Preferred Project Report

prepared in respect of MP06_0273 (MOD 1)
for the Development of

SITE 4B

SYDNEY OLYMPIC PARK

- 1A. Shadow Analysis South Building Planning Application Proposal 17 December 2010
- 1B. Shadow Analysis South Building 10/8 Level Building
2. Building Setback Along Olympic Boulevard
3. Revolving Doors
4. Plant Height
5. Canopy to South Building

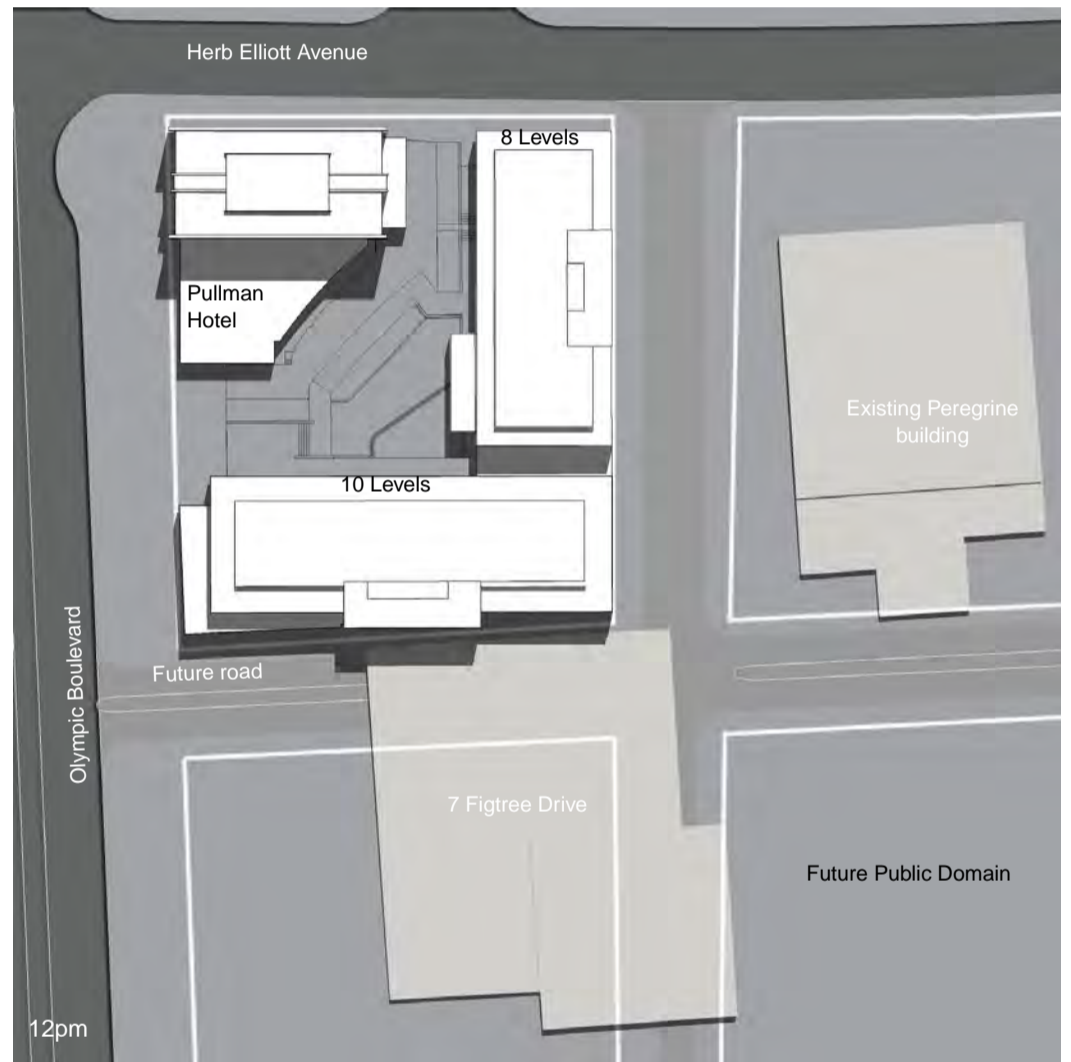
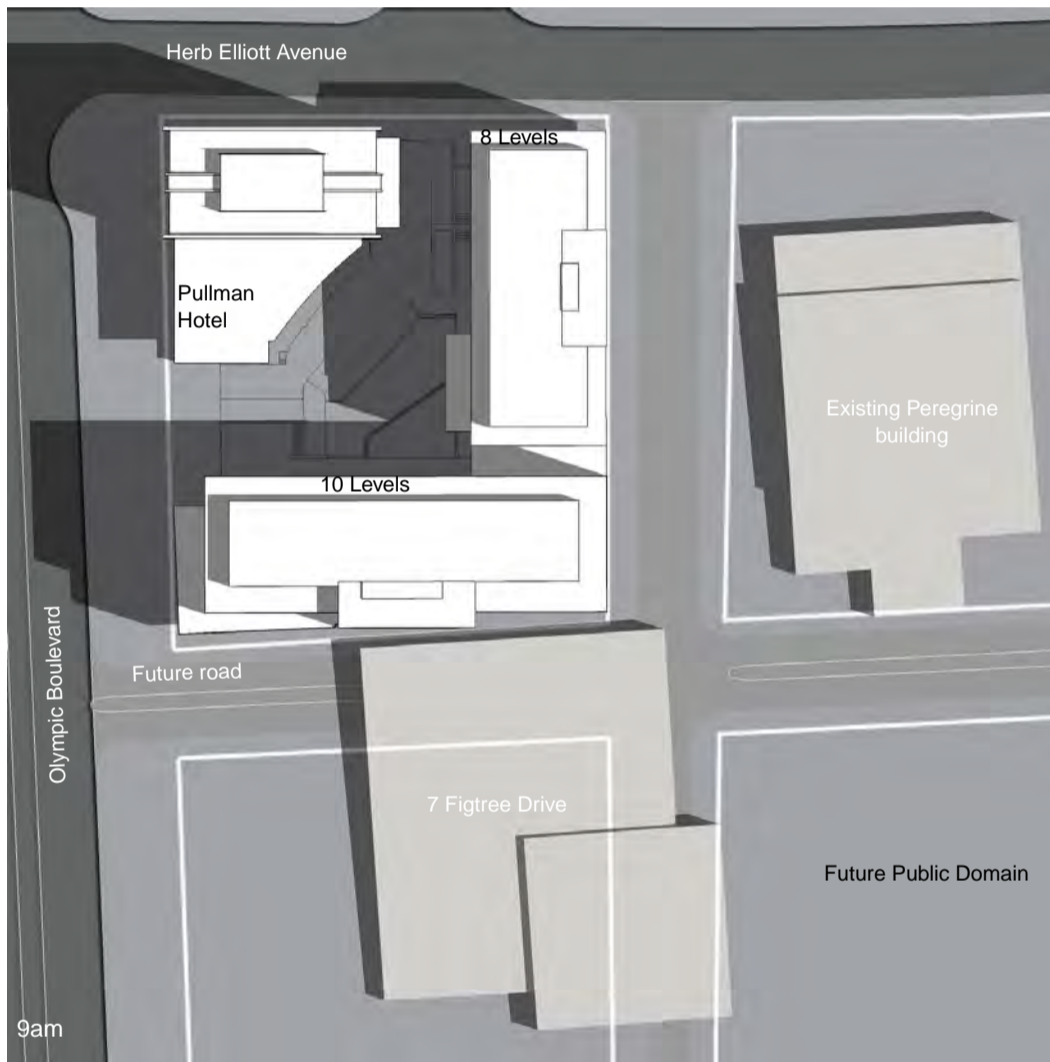
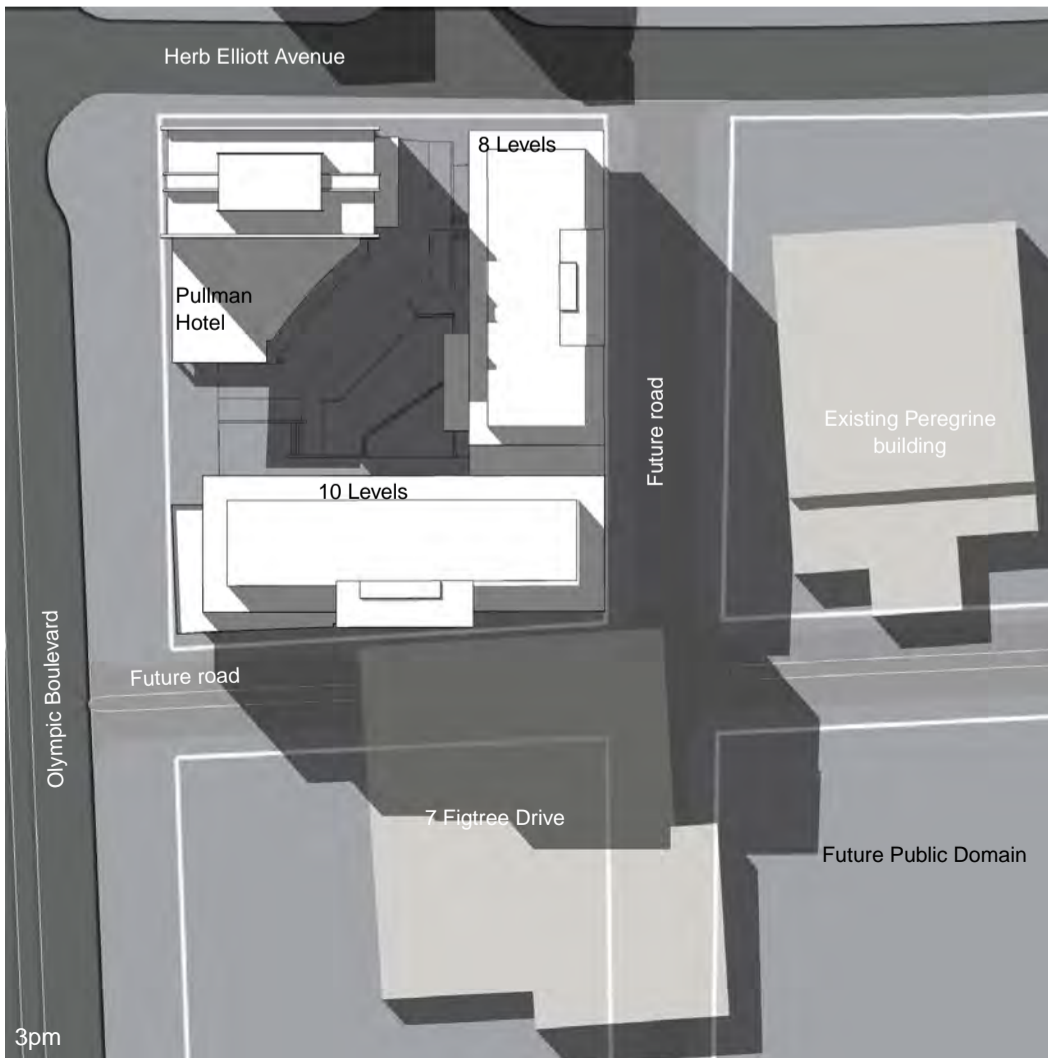
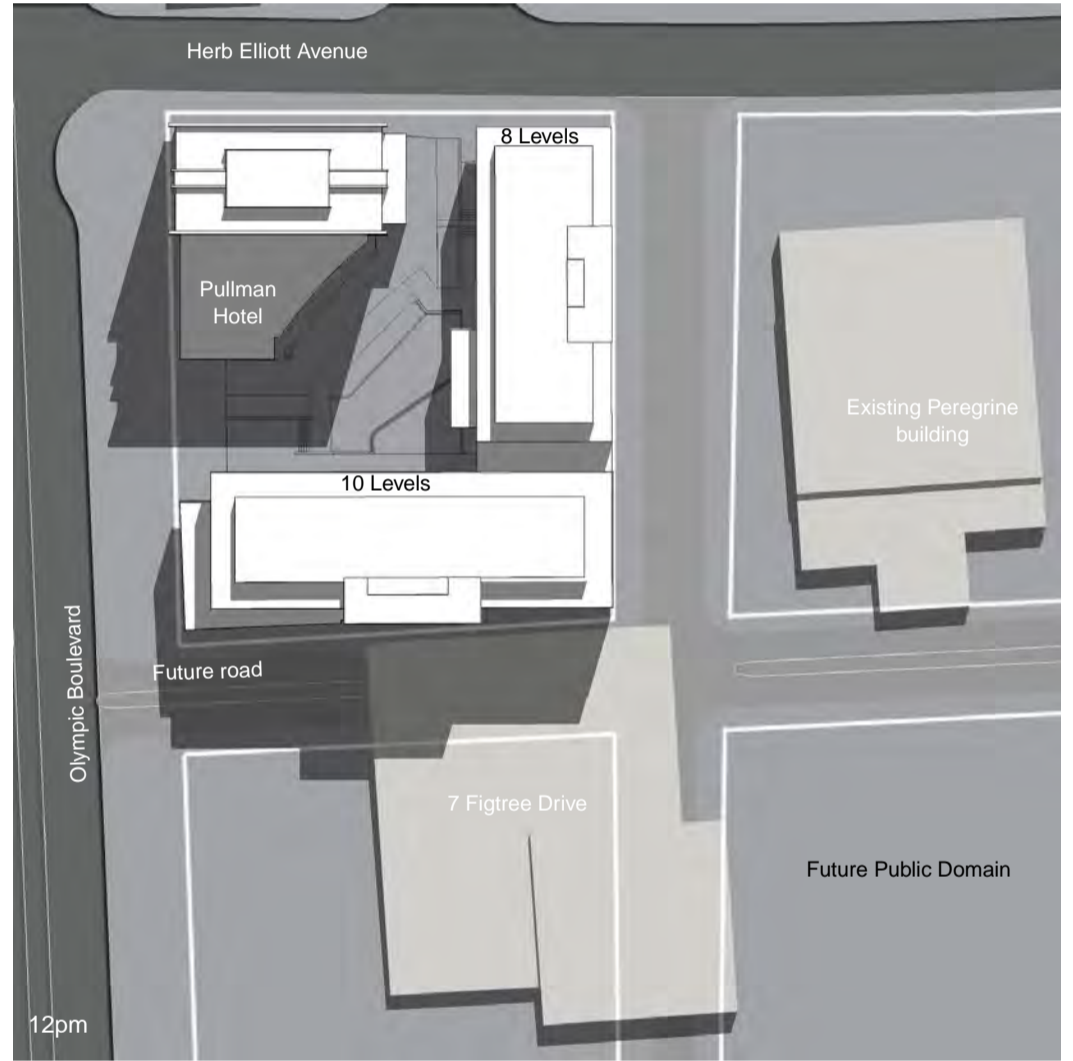
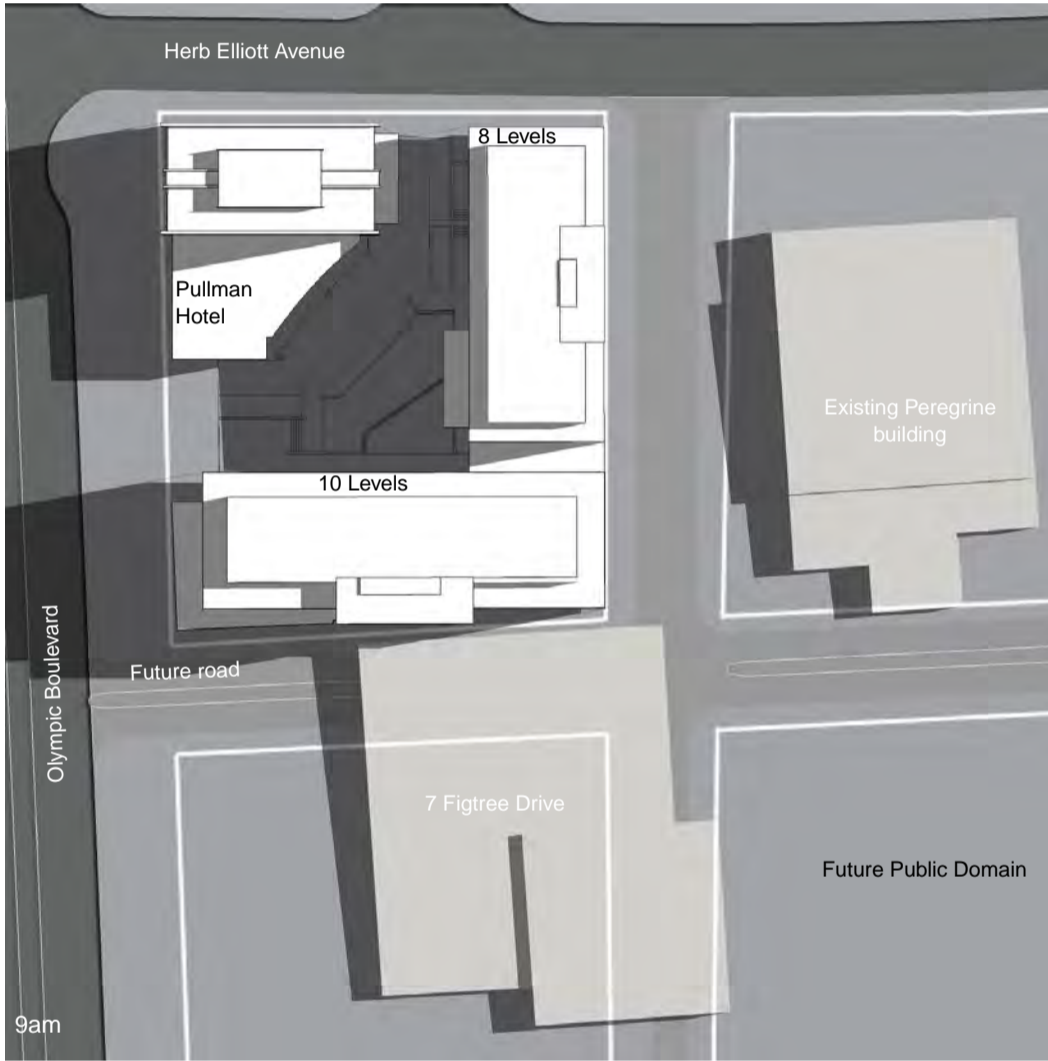
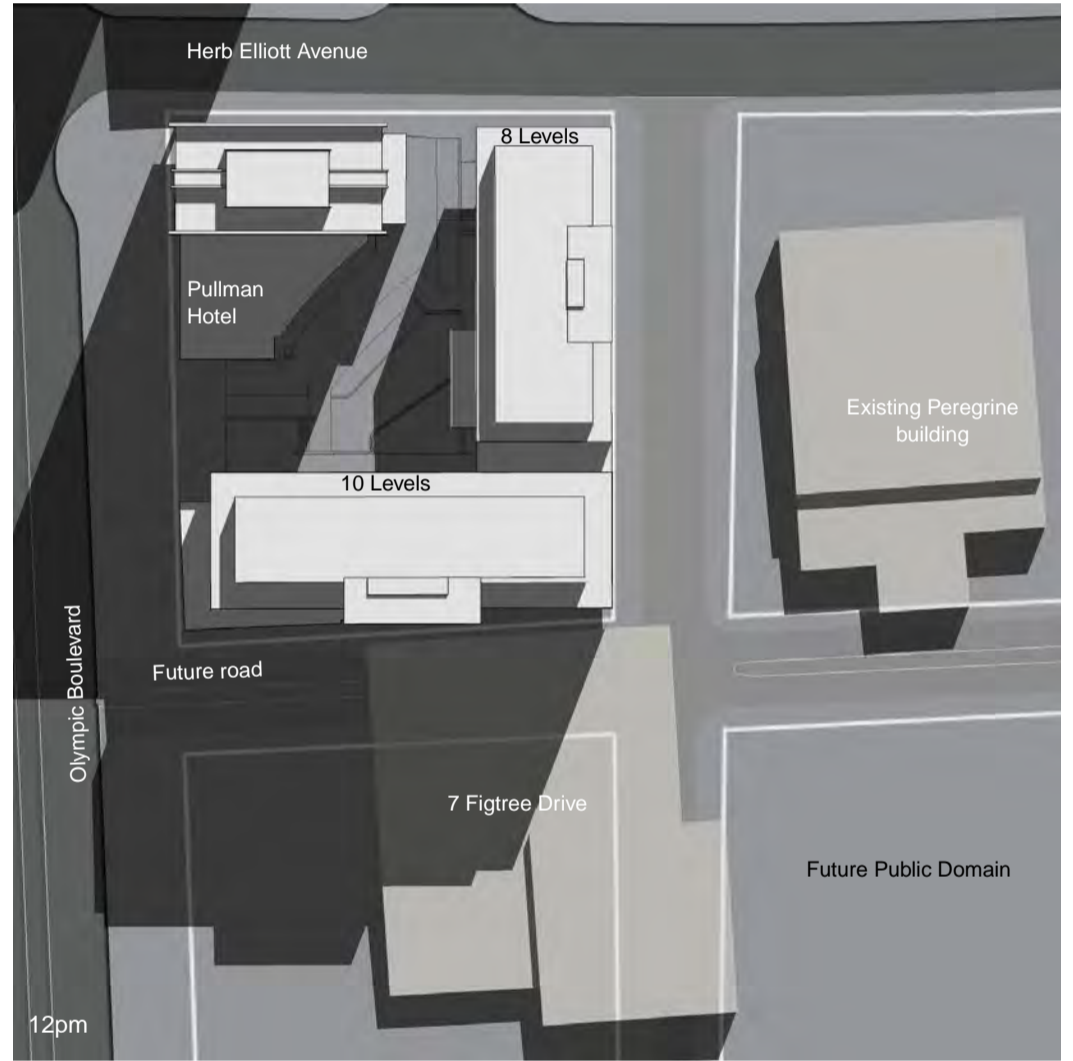
Proposed noncompliant 10 storey height of the Eastern side of the 'South Building'. Further justification is required in relation to the proposed departure from a maximum 8 storey height control, as stipulated by the Sydney Olympic Park Master Plan 2030.

The proposed increase in building massing does not result in loss of amenity due to overshadowing of the future public domain to the east. Pages 3-5 of this document show the shadow diagrams for the 10 Level South Building as included in the planning application submission of 17 December. Pages 6-8 of this document show the shadows resulting from a building with a height reduction of two levels at the eastern end of the South Building.

2. Building Setback Along Olympic Boulevard

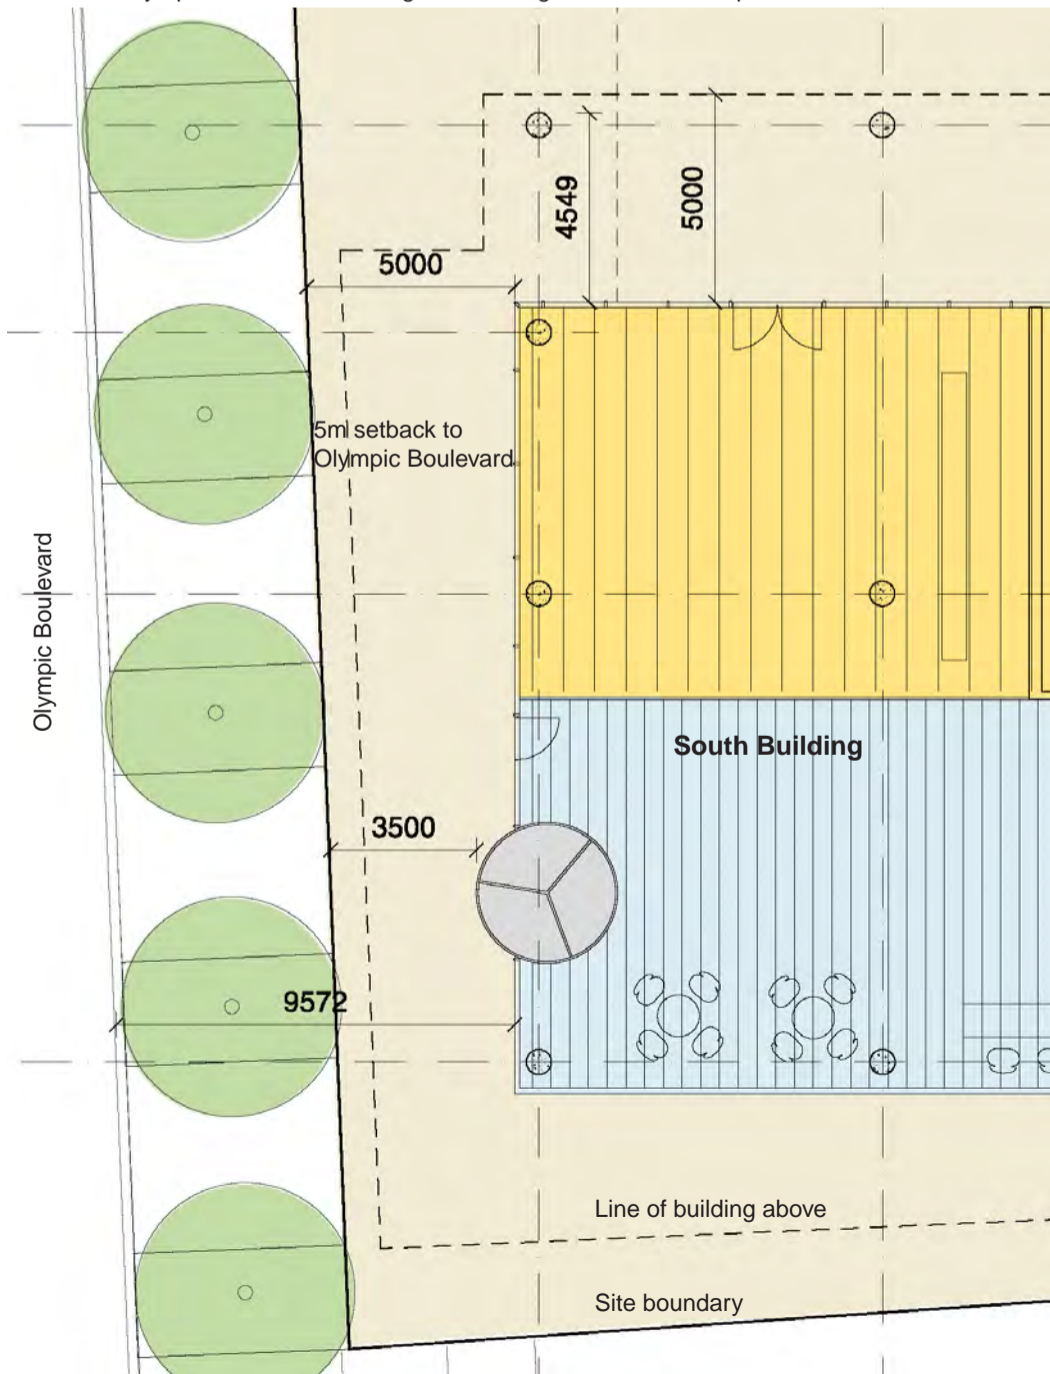
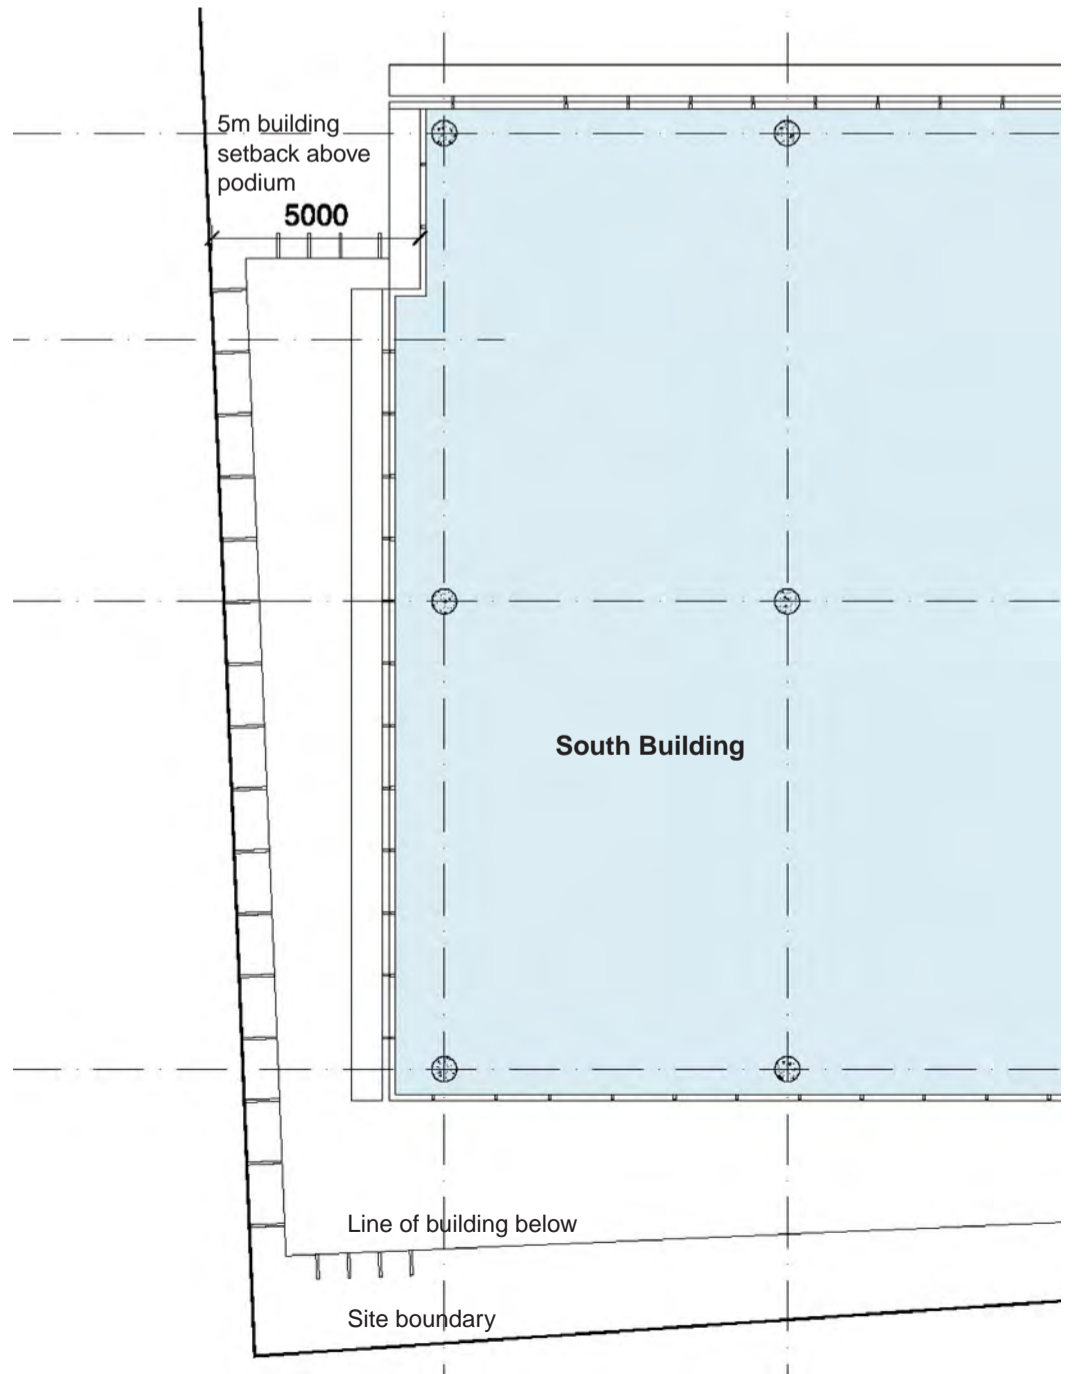
Demonstrate compliance with the minimum 5m podium setback requirement from Olympic Boulevard and minimum 4m Olympic Boulevard colonade width requirement as stipulated within the Sydney Olympic Masterplan 2030.

As shown below the South building has a setback at ground from the property boundary along Olympic Boulevard which has a maximum width of 5m and a minimum width of 4.2m at the southern end. The setback from the Olympic Boulevard kerb edge is between 9.5 and 11 metres. This zone is unencumbered by columns. The perspective adjacent shows this arrangement in more detail, including the notch to the west face of the facade articulating the corner.

Of importance is this building's relationship to the Pullman Hotel to the North. This hotel has a setback from Olympic Boulevard of 4.1m at its northern edge and a setback of 3m at its southern edge. The setbacks proposed for the South Building are greater therefore than the setbacks at the Pullman Hotel. The South building alignment along Olympic Boulevard is intended to mediate between the Pullman Hotel to the north and any new development proposed to the south on site 48.
